SERVICE BULLETIN

APPLICABILITY: 2011MY Forester Models with FB Engine **NUMBER:** 07-70-12
SUBJECT: Engine Harness Retention Clip Modification **DATE:** 09/20/12
 Procedures

Figure 2- Combination of old-style water pipe and new engine harness:

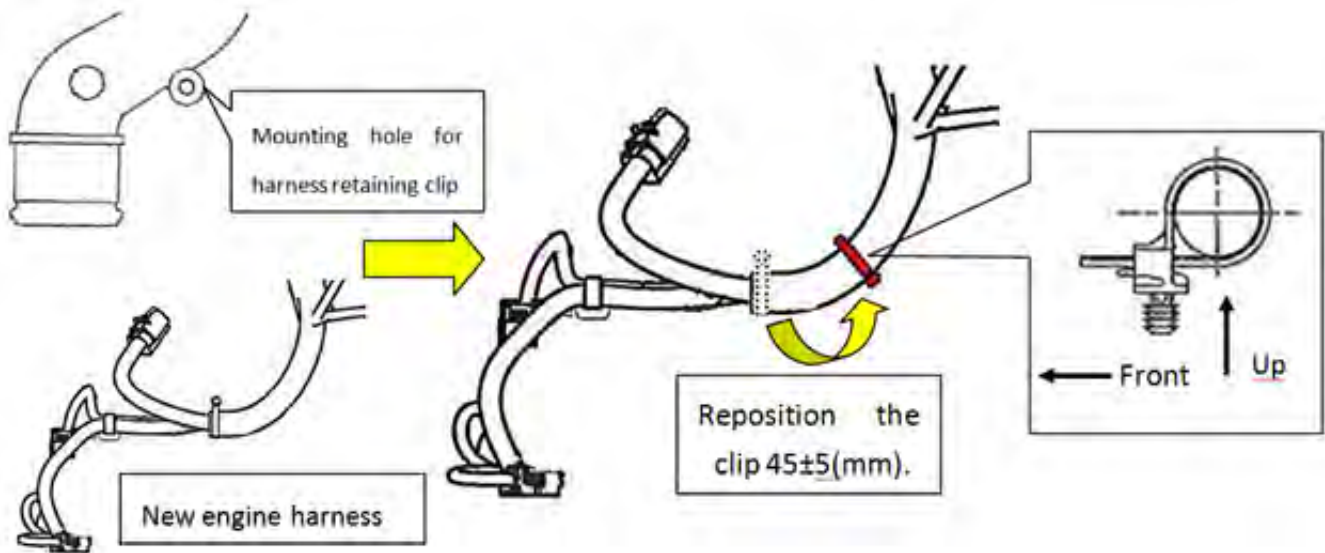
There are 2 combinations of the water pipe and the retaining clip position on the engine harness.

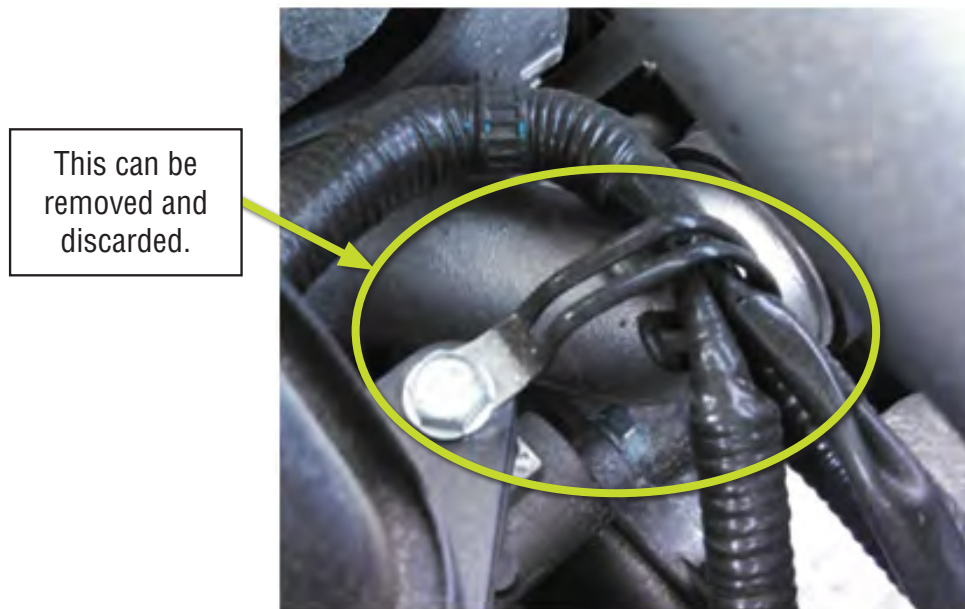
When performing the procedures in **Figure 3**, after repositioning the harness retaining clip, the bendable, rubber-coated clamp indicated in the photo below can be removed and discarded.
